Paper No. 6290

The Volta Bridge†

Discussion

FIG. 33

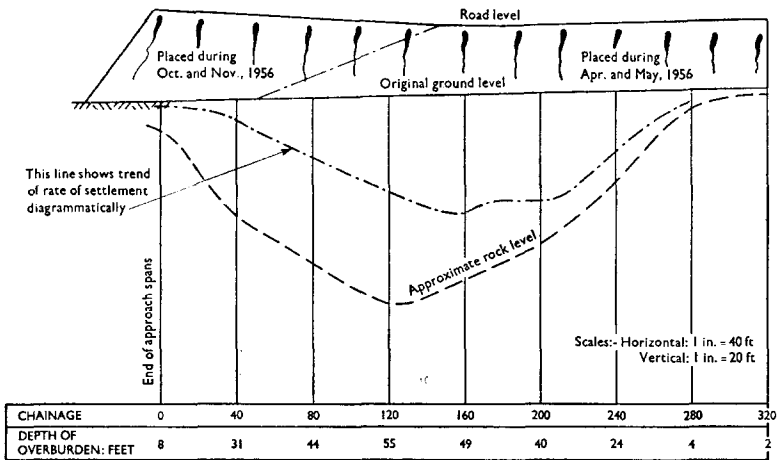
189. The settlement of the east approach embankment, amounting to 10 in. (§ 111) had continued to be the object of study. Figs 33 and 34 illustrated the course the settlement had taken.

190. There appeared to be a relation between the settlement and the depth of overburden (Fig. 33), and the conclusion which might be drawn was that the major part of the settlement was taking place in the overburden and not in the embankment itself.

FIG. 34

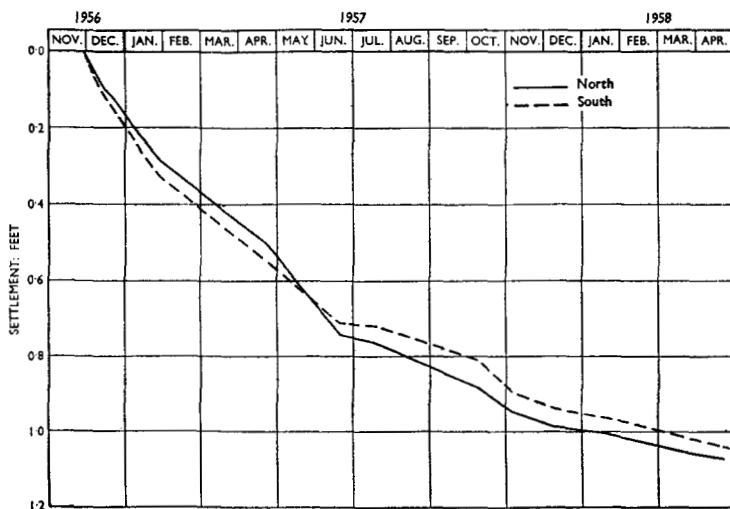
191. Settlement appeared to be decreasing reasonably steadily (Fig. 34), although there appeared to be a flattening of the settlement/time curve after June and October 1957, which suggested that settlement might be affected by the water-table; the river level had reached a minor peak in June/July, the main flood occurring in October.

192. Some settlement must have occurred before the commencement of recordings.

and a rough estimate showed that this might have been as much as 12 in. Including this figure, the maximum settlement since construction of the embankment might now have reached about 2 ft 4 in. Some compensation for settlement had been made after the placing of the main fill, so that the apparent settlement was not more than about 1 ft 4 in. In this case it appeared to be more practical and economical to await events, and subsequently to reinstate the road if required, rather than to carry out expensive soil investigations and/or expensive works in order to predict and forestall this contingency.
